Access Compliance Report Public Rights-of-Way (Curb Ramps)

Main Street: OSO_PKWY		Cross Street: MORNING_TRAIL		Location: NE
ADA ID: RPRK211021124644	Ramp Type: Type 1 - Perpendicular	Initial Pass/Fail: Fail	Overall Compliance: No	Severity Score: 30

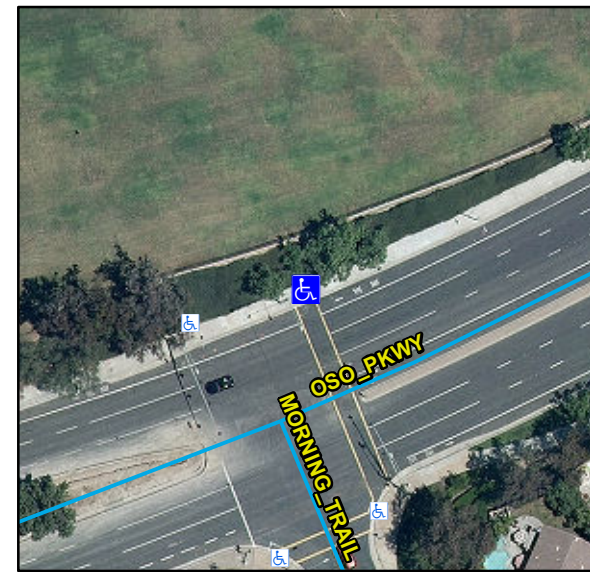
R304.2.2, R304.5.3, STD 1115

Remove & Replace Entire Ramp.
